81-103 King's Road

Welcome to our second round of Community Meet and Greet events.

As previously noted during the last round of consultation events held in May, the design team have undertaken a review of the consented scheme, alongside supporting information including the fire strategy, and new survey information. This review has resulted in the team identifying several minor amendments that will be required to deliver the consented building.

Proposed Amendments

Front Façade – Proposed

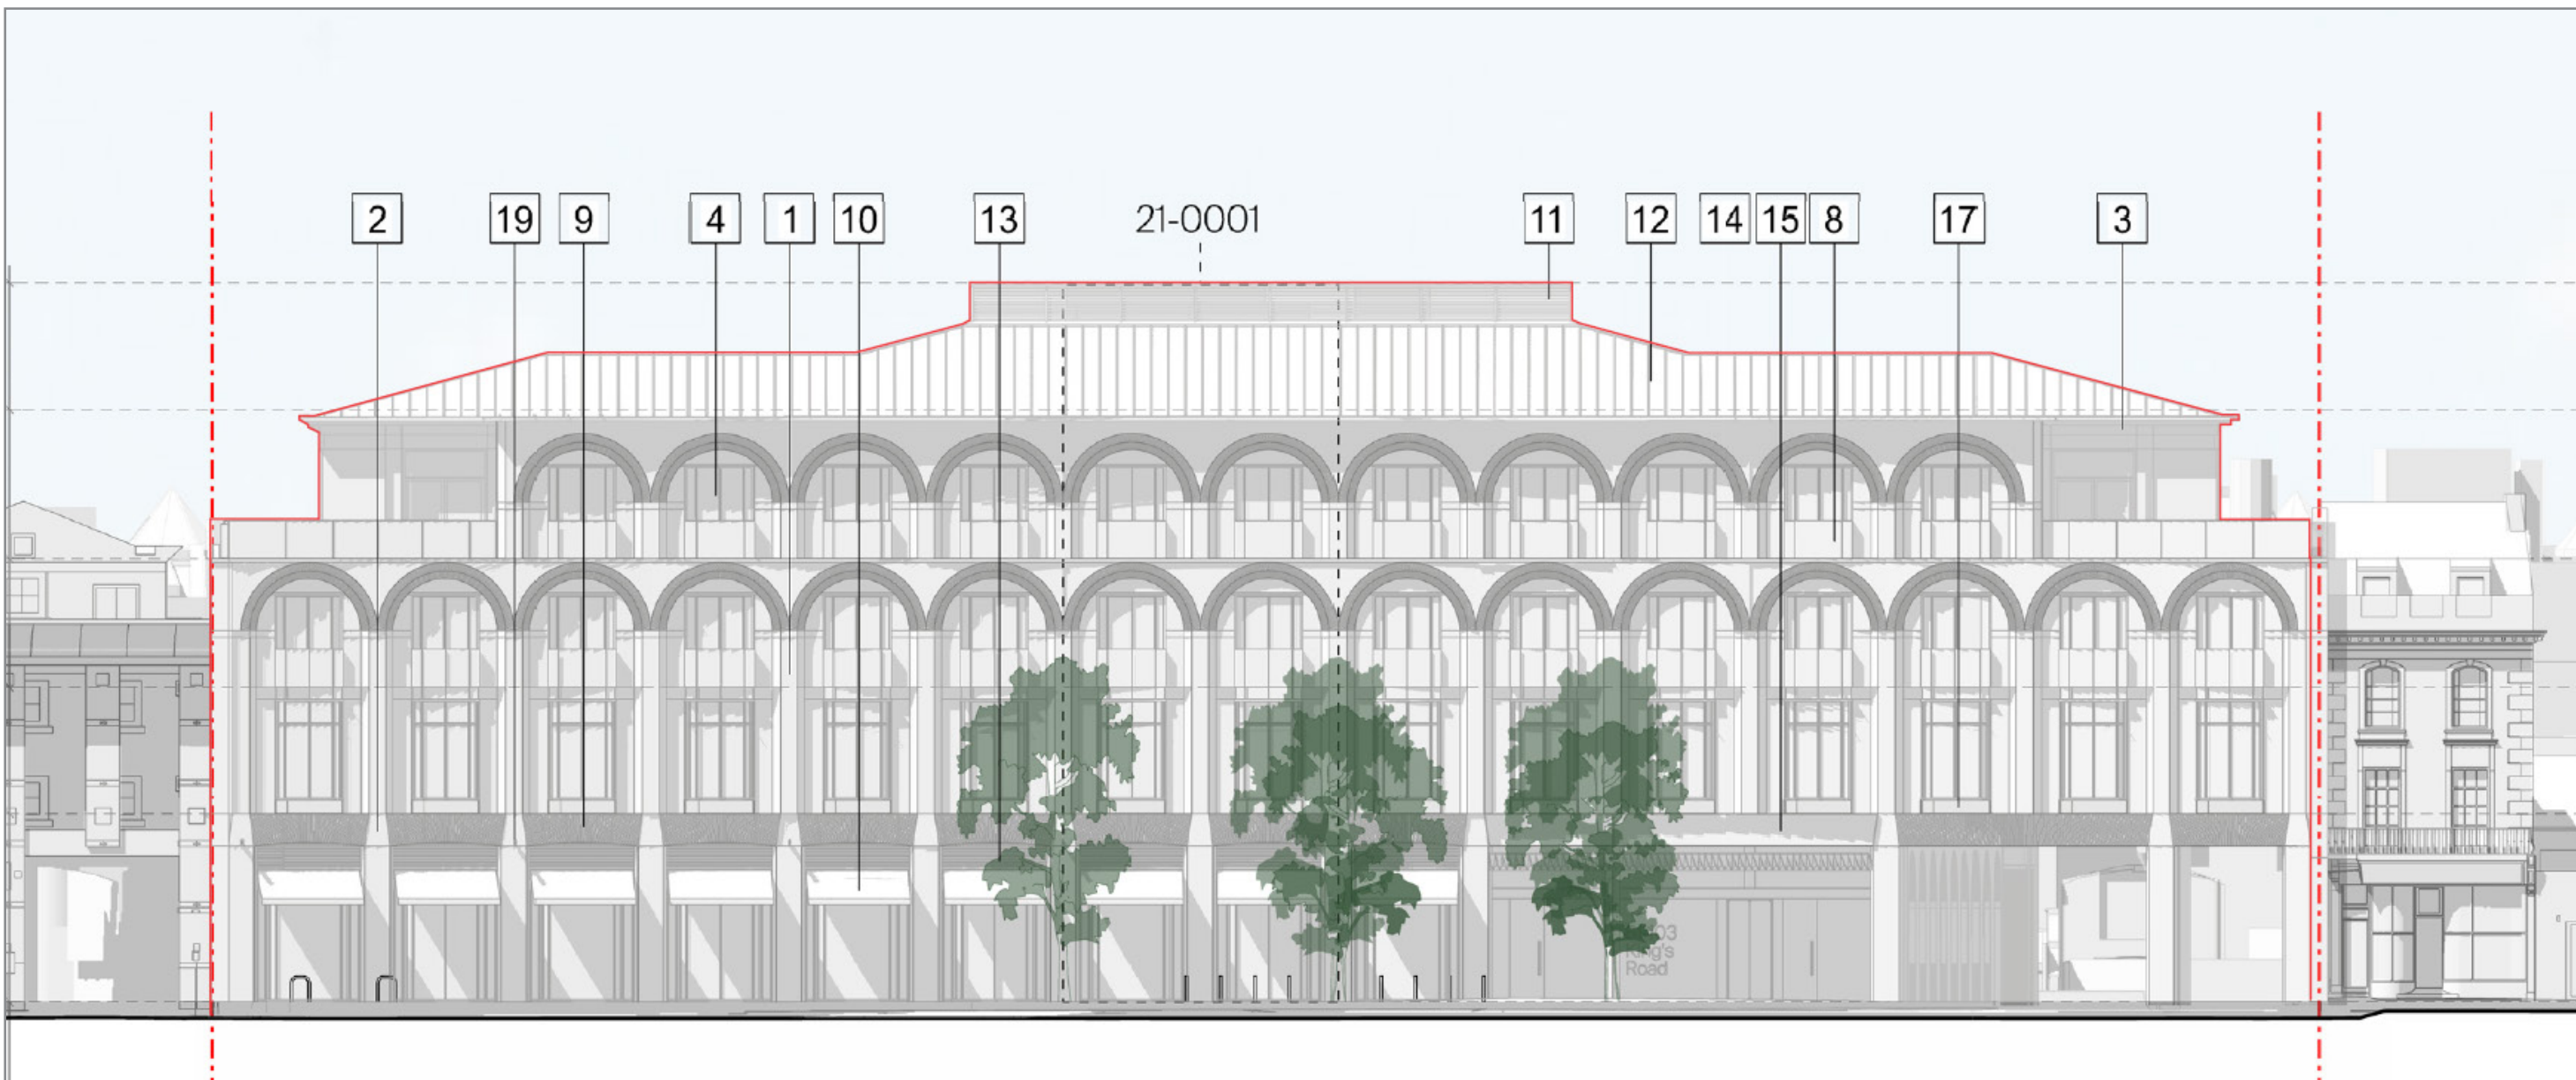
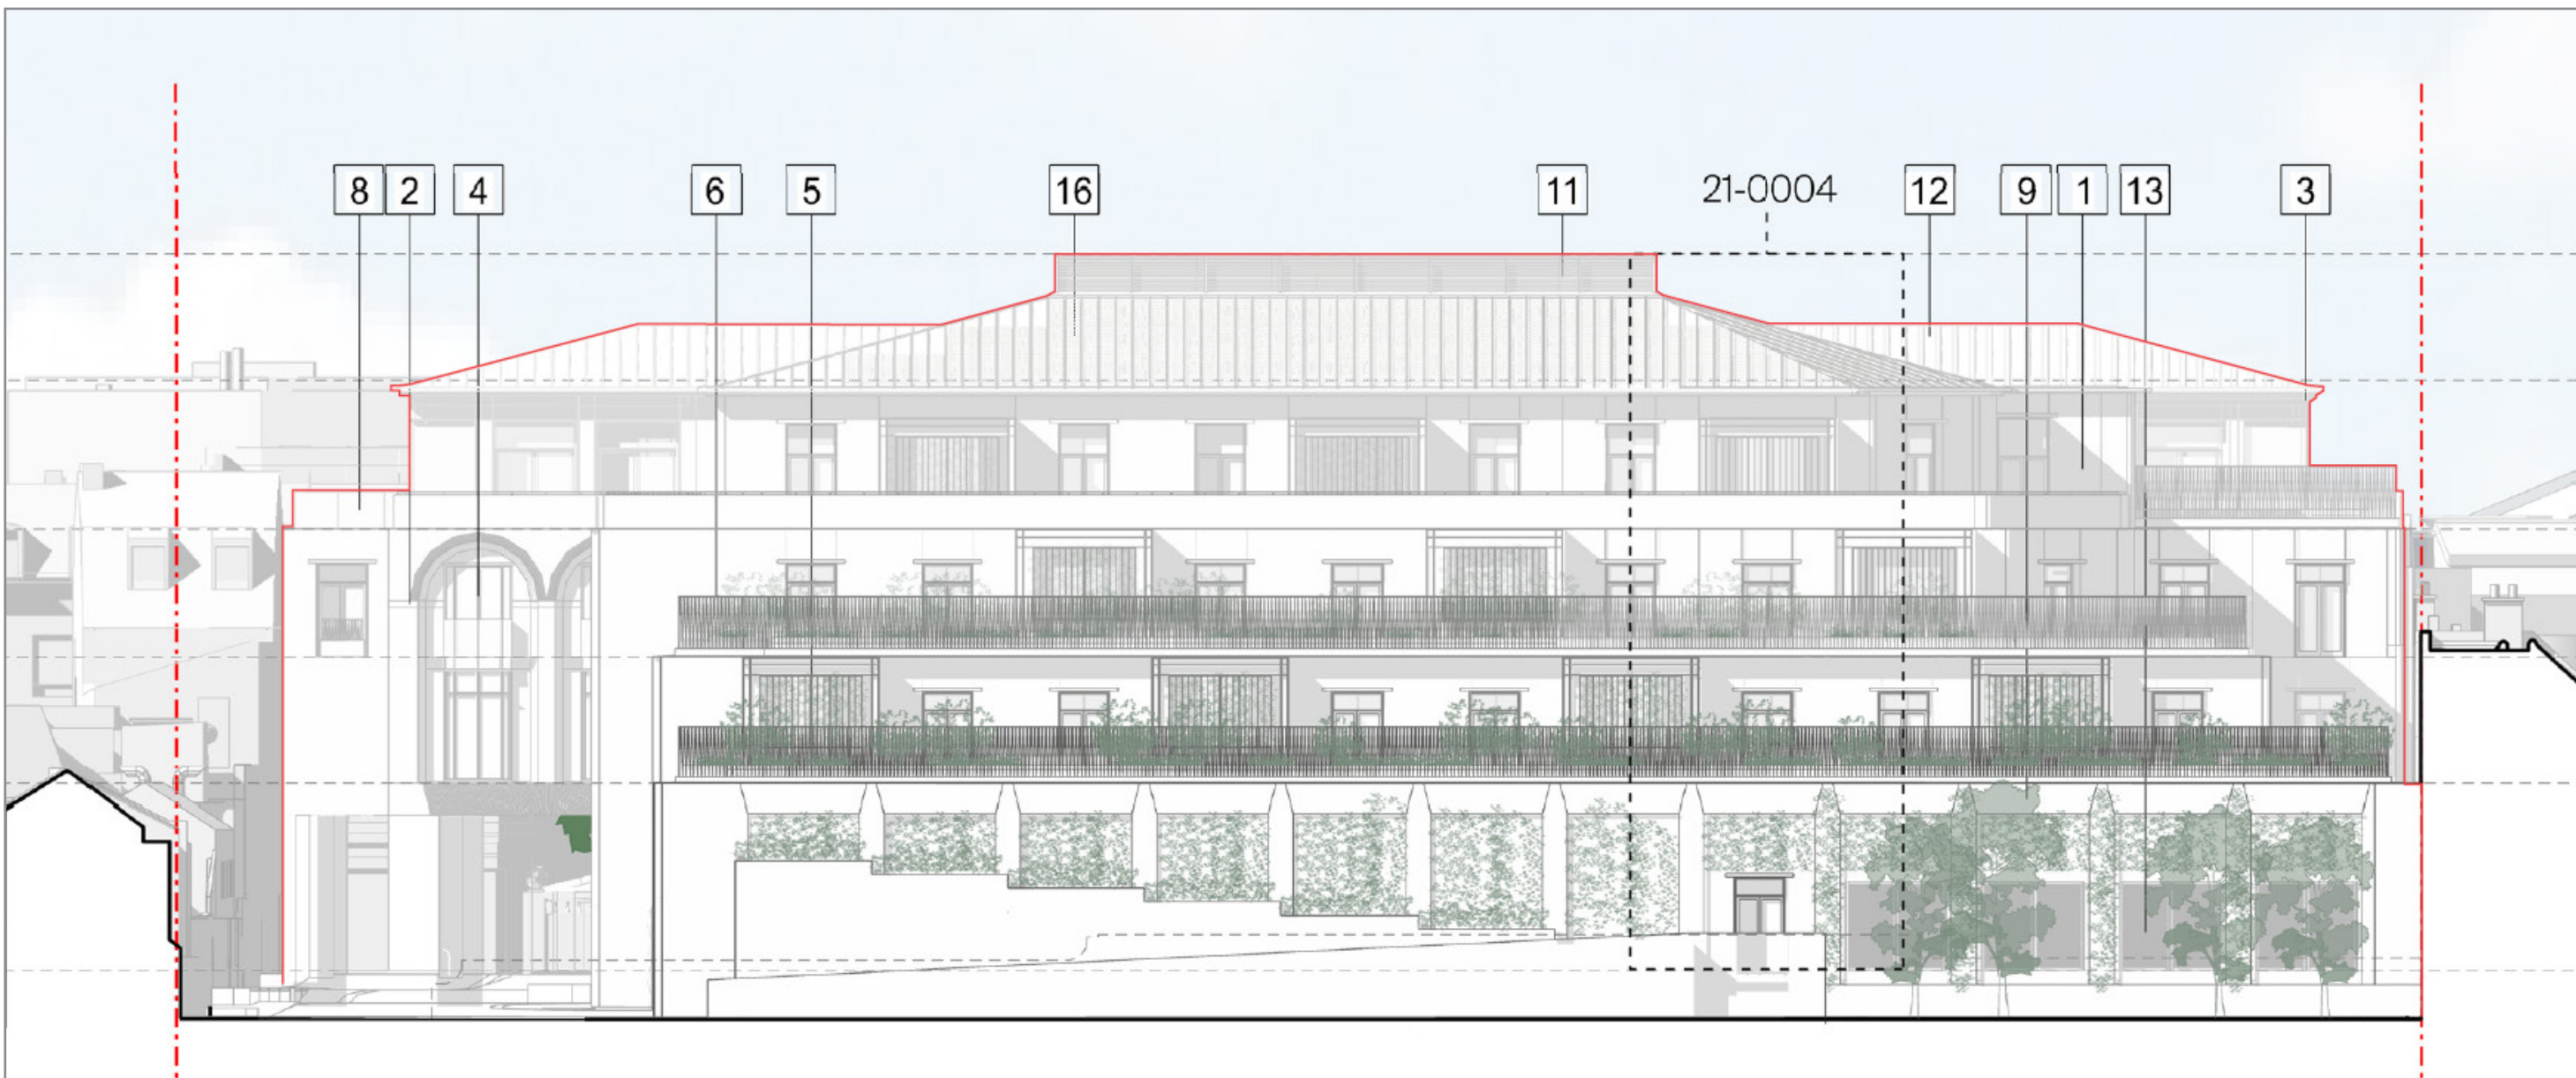
| 3 Bronze finished PPC metal channel | 7 Bronze finished PPC metal decorative gate | 10 Fabric awning (omitted in proposed) |

| 12 Zinc standing seam roof (omitted in proposed) | 16 Roof-mounted photovoltaic panels | 19 Signage |

Urban Greening

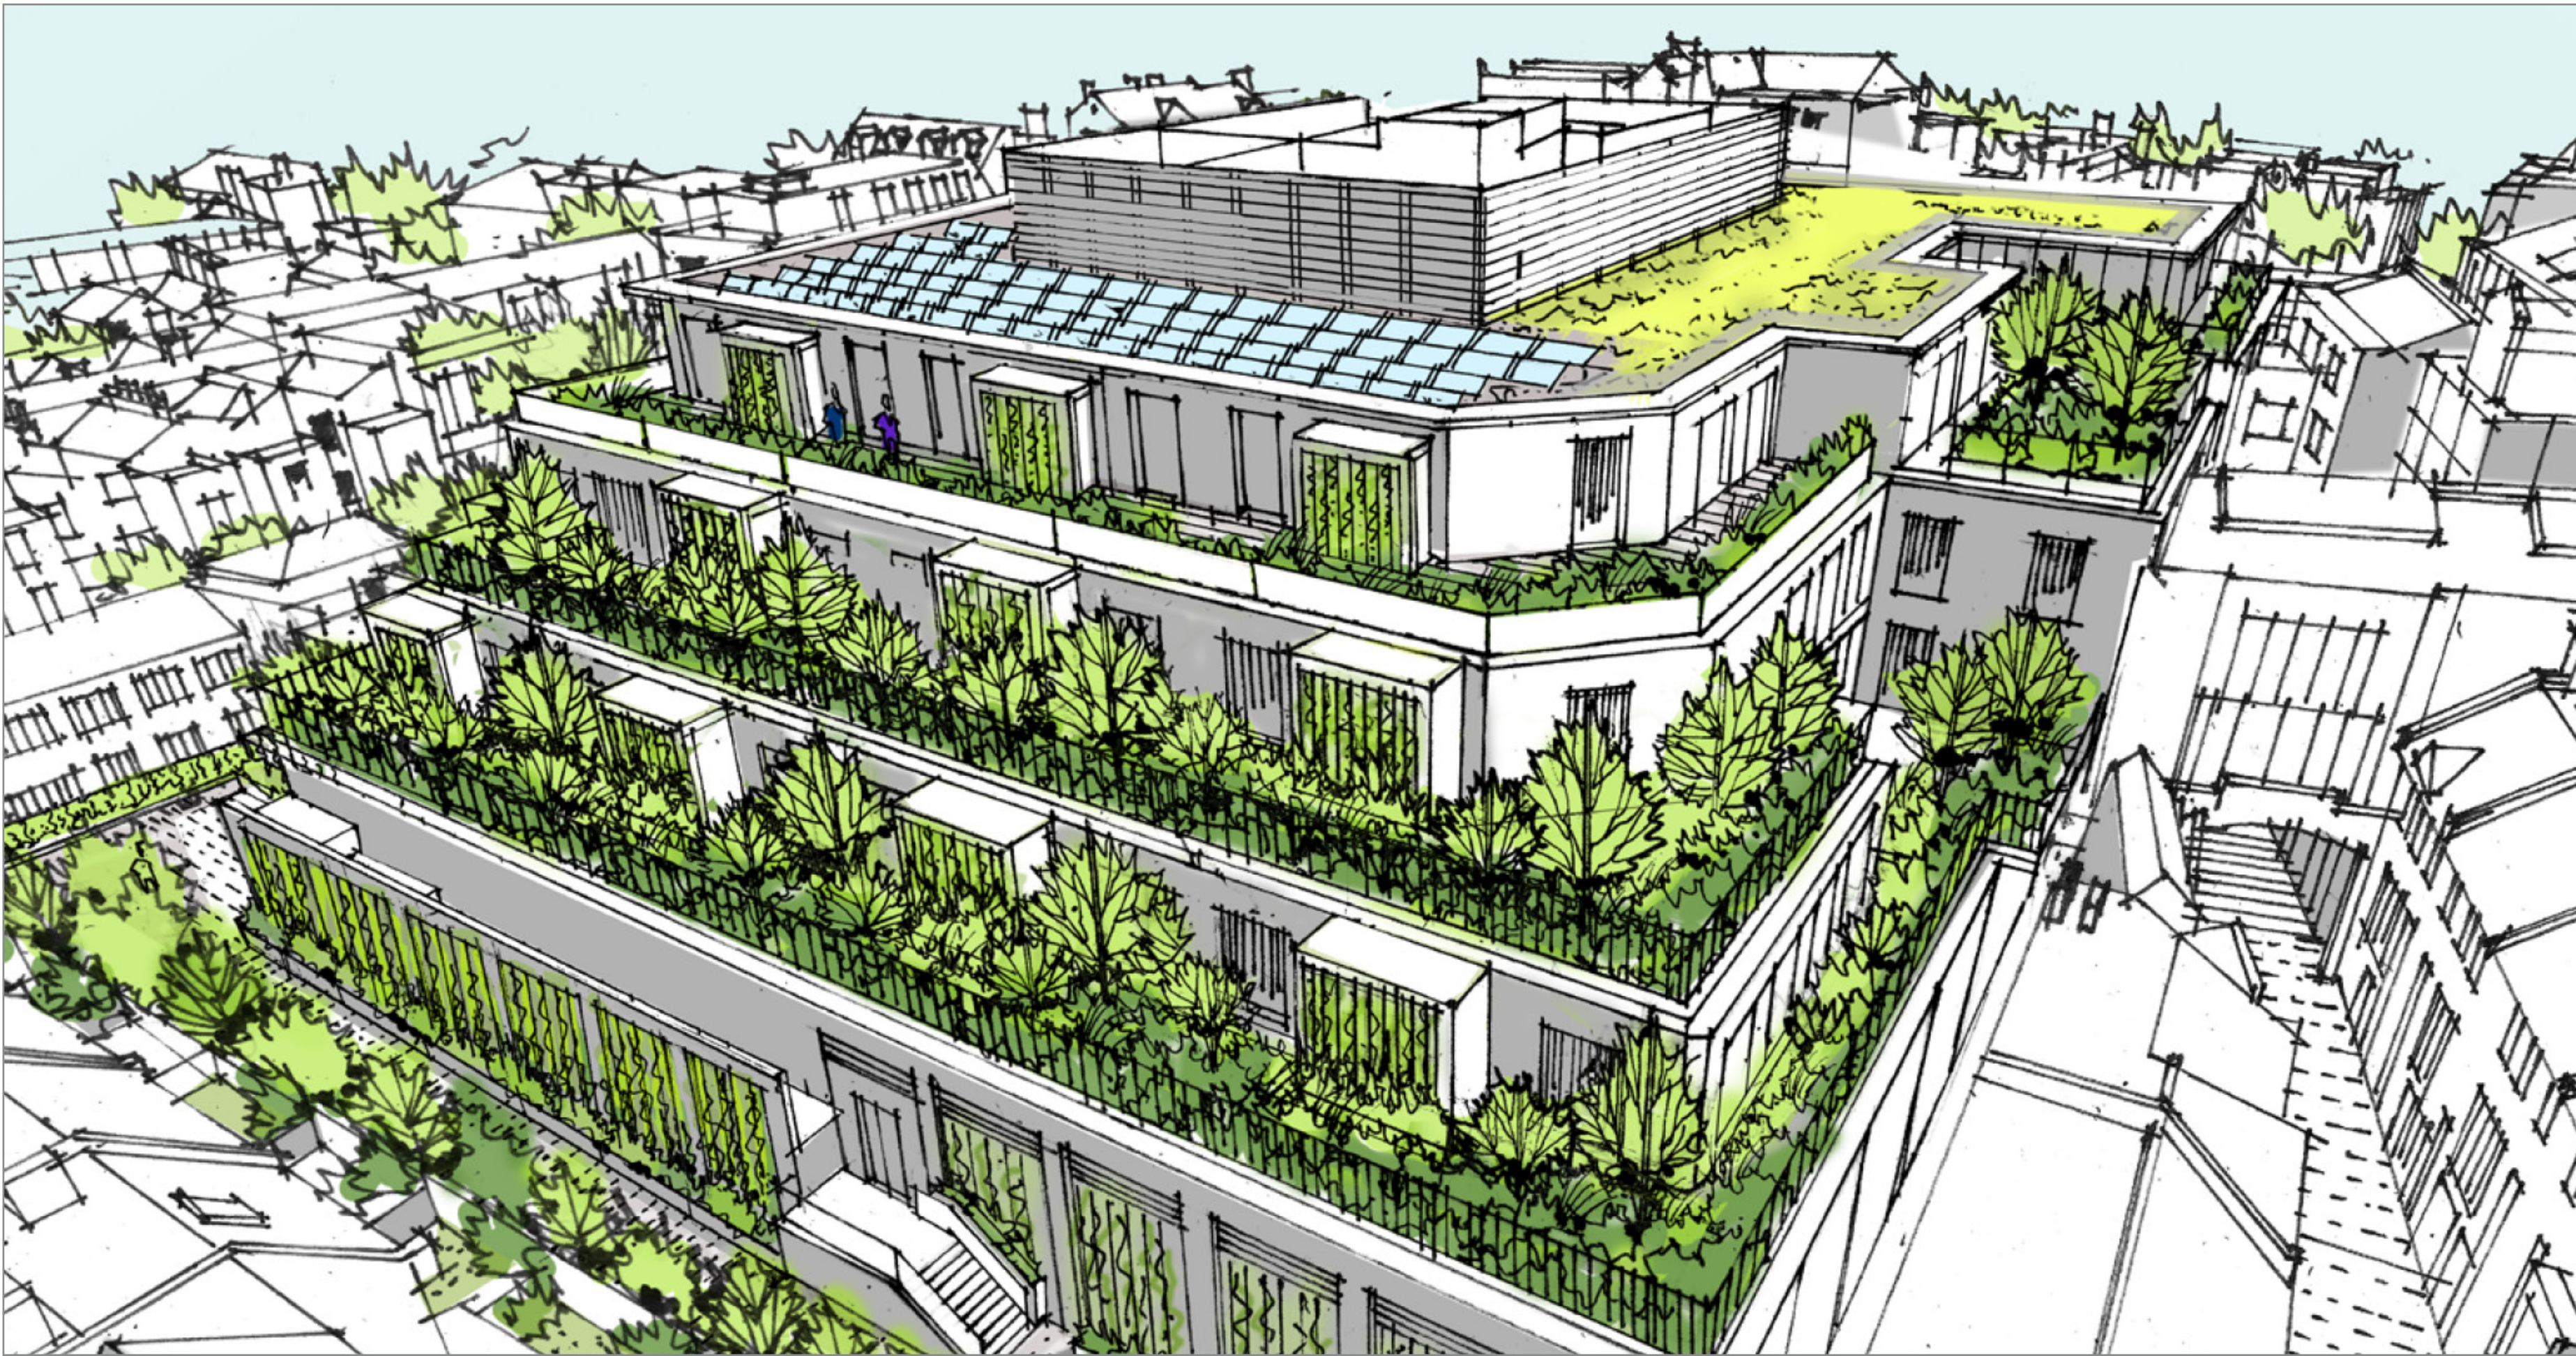
The landscaping scheme is being updated to adjust for the amendments to service road access and pedestrian fire egress routes. Some trees (as set out in the previous consent) along the service road will be removed for vehicle access, and planting will be rearranged to allow for escape routes.

New greening will be added that includes linear planters along the west side of the service road, climbing plants, and a green roof at the top of the building.
